NEI/INDUSTRY PROPOSED REV 1 Aug 4, 2000

Appendix E

Physical Protection
Significance Determination Process

# Physical Protection (Sheet 1)
# Significance Determination Process

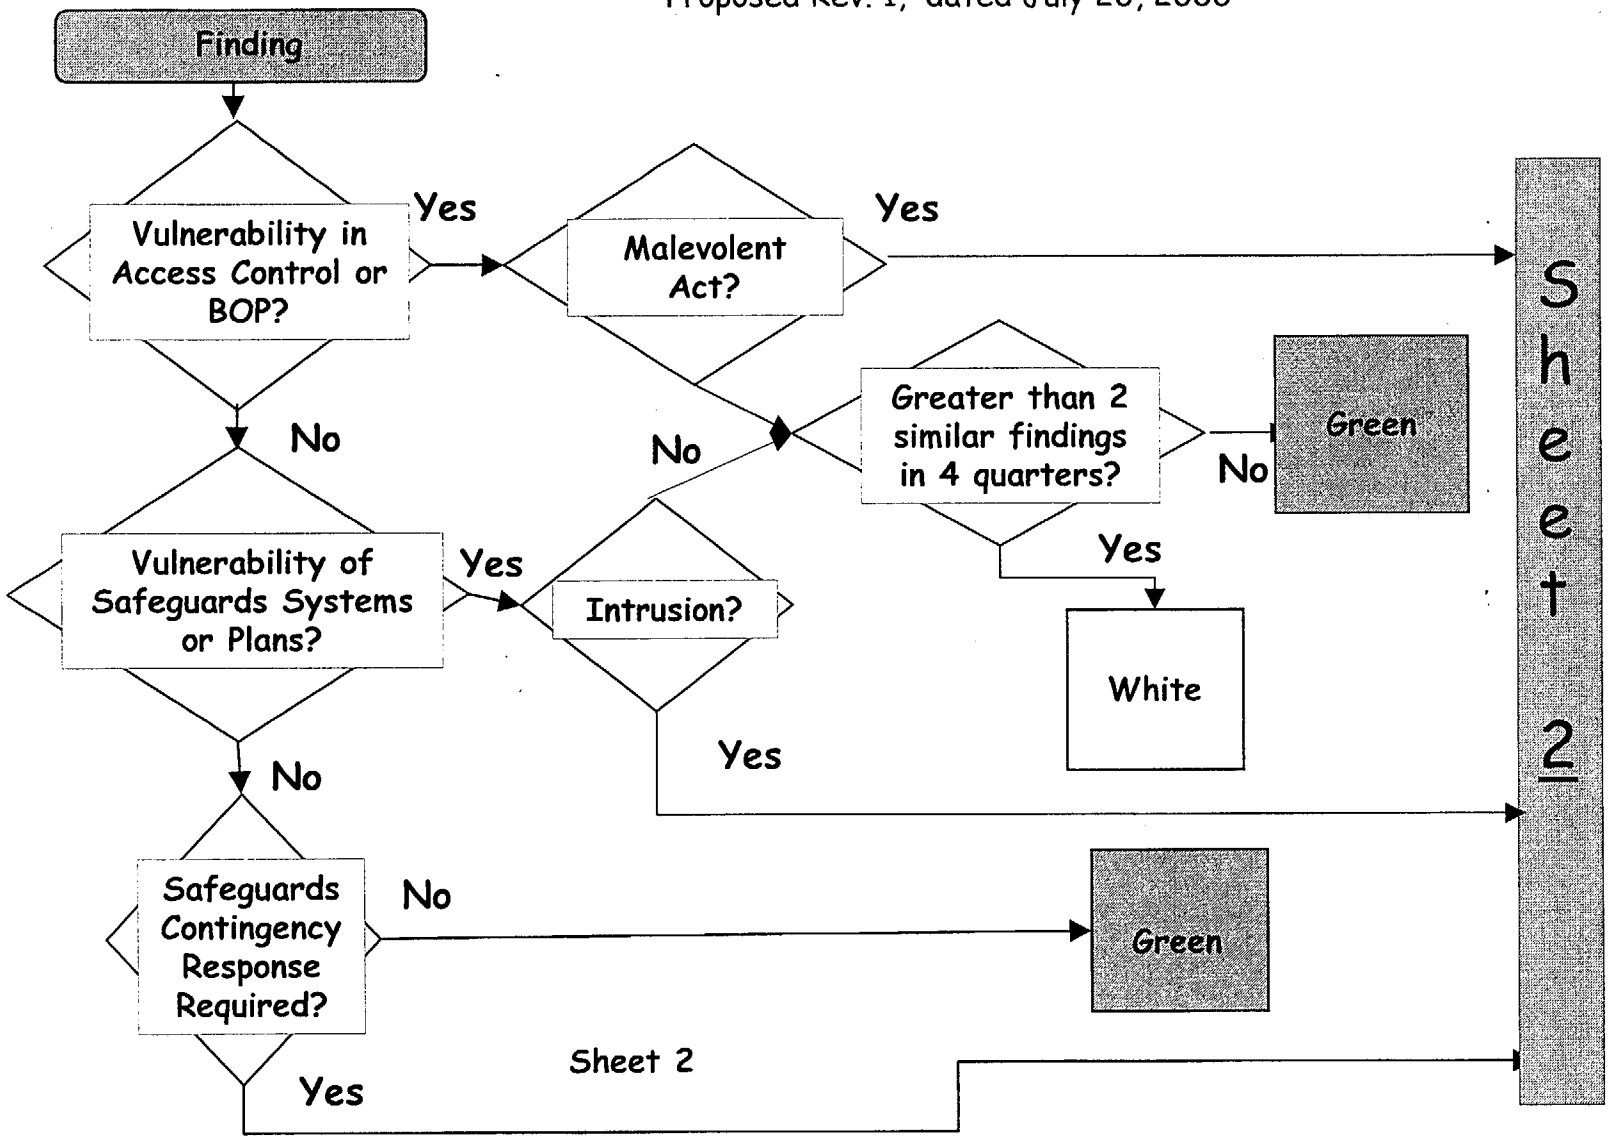
4. On Logic chart Sheet 1—Why does one branch block have "Intrusion?" while another branch block has "Safeguards Contingency Response Required?" if the first automatically leads to the second? Please provide some examples/scenarios using the thought processes expected for making determinations with these fault-trees.

# Physical Protection (Sheet 2)
# Significance Determination Process

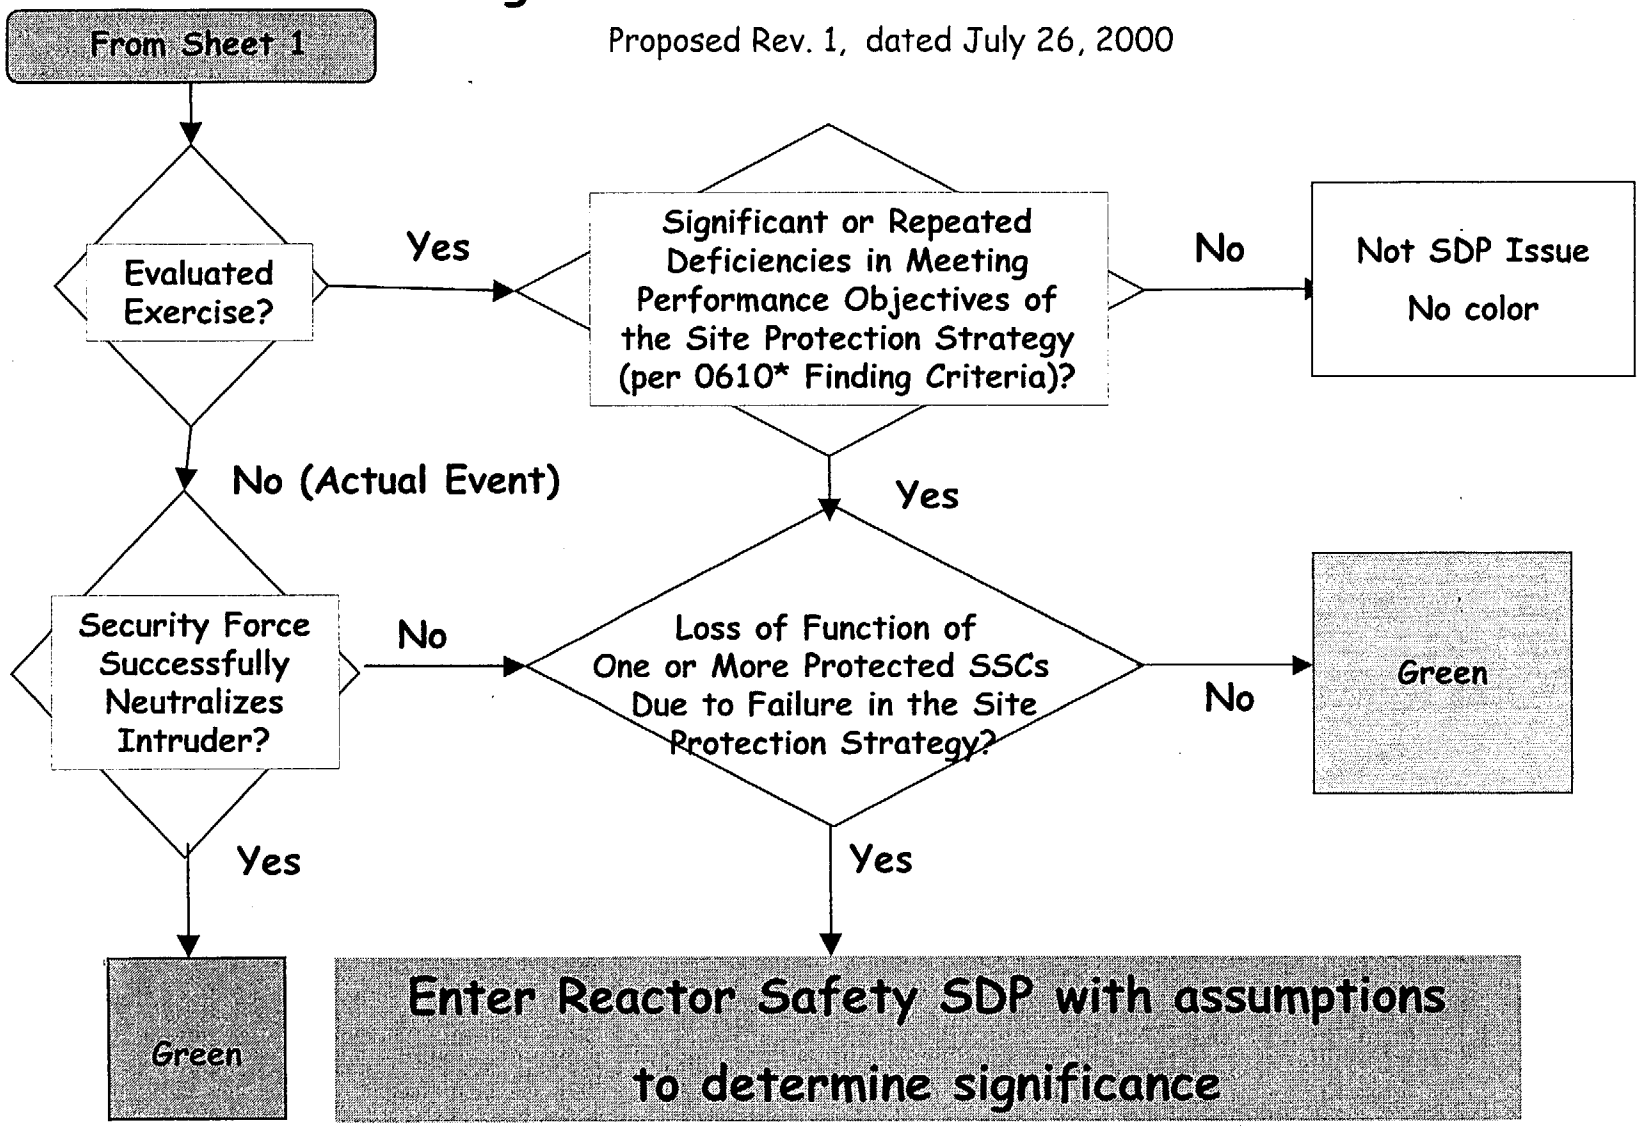
3. The Reactor SDP is entered (Logic chart Sheet 2) if there has been a loss of function of one or more protected SSCs due to failure in the site protection strategy. Does this mean that the protection strategy has failed if the function of one SSC is lost even though the strategy allowed for this occurrence by a fall back depth-in-depth strategy? If so, why?

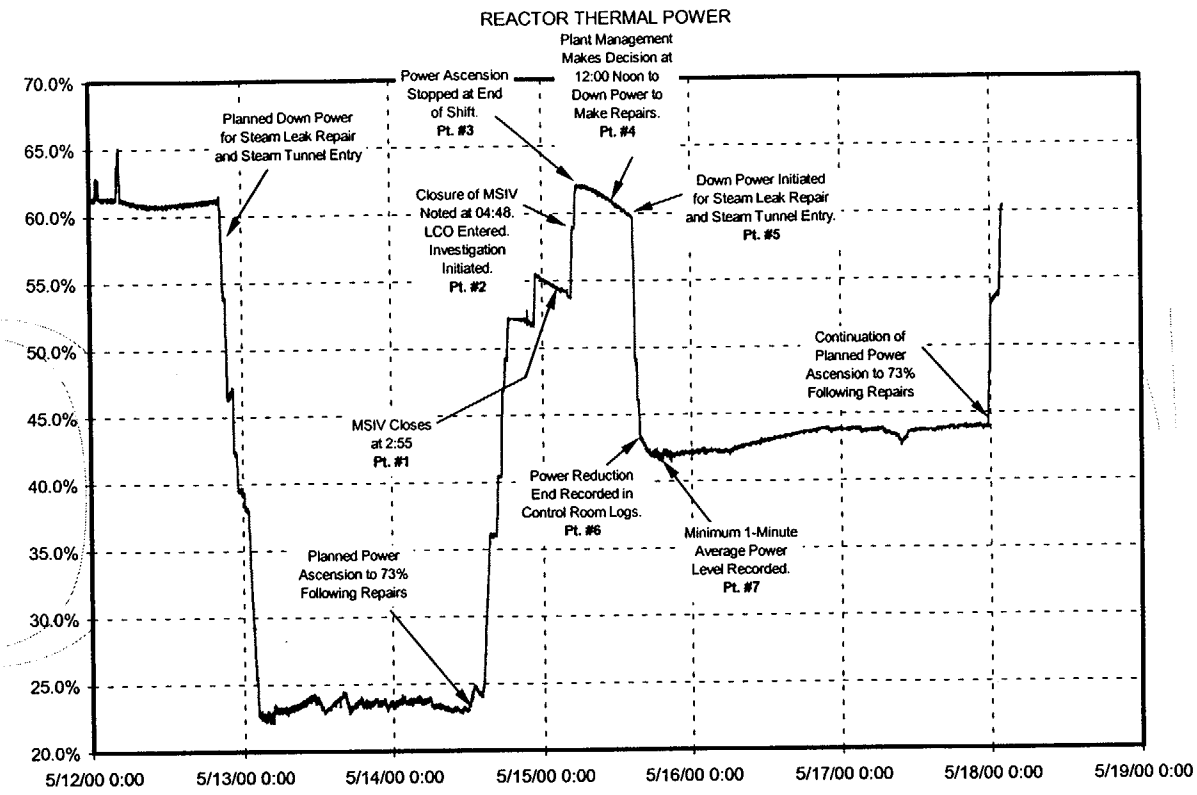
| *Temp No.* | *PI* | *Question/Response* | *Status* | *Plant/ Co.* |
|---|---|---|---|---|
| *12.7* | *IE03* | ***Question:***<br>*Should the unplanned power change outlined below be counted from the point the off-normal condition is discovered or from the point that action is taken in response to the off-normal condition?*<br><br>*May 14, 2000:*<br>• *The station was operating at approximately 24% power in order to repair steam leaks.*<br>• *11:57 AM - Power ascension was initiated with the intent to go to 73% power in a mode of load following.*<br>*May 15, 2000:*<br>• *The crew on shift has a goal of reaching 61% power.*<br>• *2:55 AM - One main steam isolation valve (MSIV) closed due to loss of air. The other three main steam lines are unaffected. No power change results from the MSIV closure. Power level is 54.3%. (one-minute average heat balance power data)* ***Point #1.***<br>• *4:48 AM - The MSIV is discovered to be closed. Power level is 58.8% (one-minute average power data).* ***Point #2****. Power ascension is continued using reactor recirculation flow*<br>• *5:12 AM - Suspended reactor power ascension for the shift. Reactor Power is 62%* ***Point #3****. Several times over the next few hours the peak one-minute average power reached 62.1%.*<br>• *12:00 Noon - A management meeting is conducted and a decision is made to reduce power for ALARA concerns and enter the steam tunnel to investigate the cause of the MSIV closure. There is no technical specification driver involved. Specifically, there is no regulatory driver to complete a repair by a specific time or to be at a specific power level within a given time. Power level has decreased to 60.6% (one-minute average power) due to xenon.* ***Point #4****.*<br>• *2:35 PM - The Control Room Log entry notes reactor power at 61%. The one-minute average power level is 59.3%. The power reduction was initiated by reducing reactor recirculation flow in preparation for inserting control rods.* ***Point #5****.*<br>• *3:34 PM - Completed moving control rods for the down power. The power reduction for the steam tunnel entry is complete. The Control Room Log entry notes power at 43%. The one-minute average power is 43.6%.* ***Point #6****.*<br>• *5:15 PM - Power reduction complete. The one-minute average power is generally 42%. However, it varies from 41.9% to 42.3%.*<br>• *8:40 PM - The power level is being controlled using control rods and reactor recirculation flow. Power went as low as 41.4%(one-minute average) after movement of control rods.* ***Point*** *#7.*<br>• *About 11:00 PM - Power is raised slightly over the next few hours to ensure that power fluctuations don't inadvertently increase the magnitude of the total power change.*<br><br>*In the case study above, the off-normal condition was discovered at 4:48 AM, noted as Point #2, and the power level was 58.8%. The power ascension continued to Point 3, with one-minute average power level of 62.1%, and then reduced to 42% (Point #6) to investigate the cause of the condition.* | | *Colum bia* |
